STAFF REPORT TO THE PLANNING COMMISSION
Prepared April 12, 2021

- FILE NUMBERS:** L19-0115 Comprehensive Plan/Zoning Code Amendment
E19-0011 SEPA Checklist
- REQUEST:** Zoning Code amendments to TMC 18.41 and new design guidelines for multifamily development in the Tukwila South Overlay (TSO) district.

Figure 2.4.B

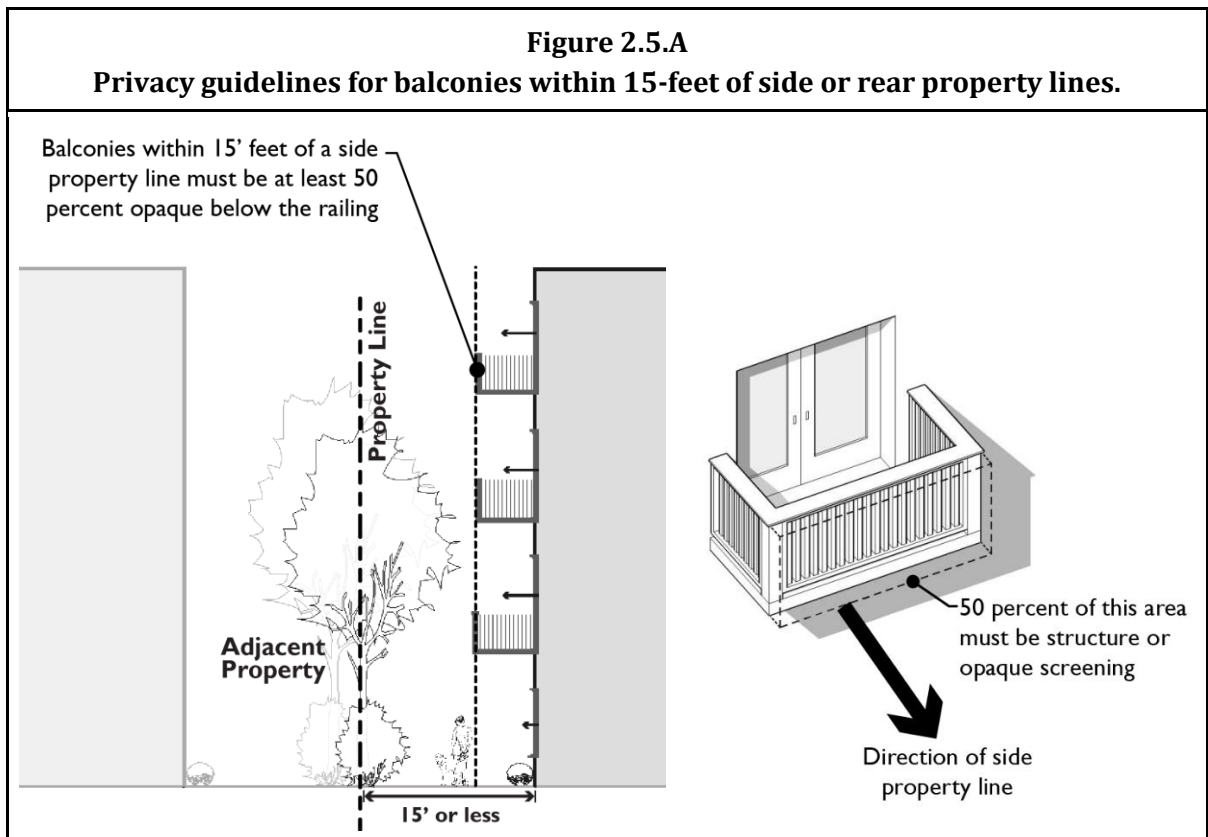
- Provide additional clarification for who has authority to approve modifications from design guidelines.
- Revise Figure 2.4.B to better clarify between individual and common recreation spaces.
- Revise Utility Screening section and Figure 2.6.B to require screening of rooftop utilities from above if potentially visible from future adjacent developments projects.
- Provide option for 100% glazing for bathrooms facing public spaces.

These revisions have been incorporated into the Proposed Tukwila South Residential Design Guidelines, Attachment C.
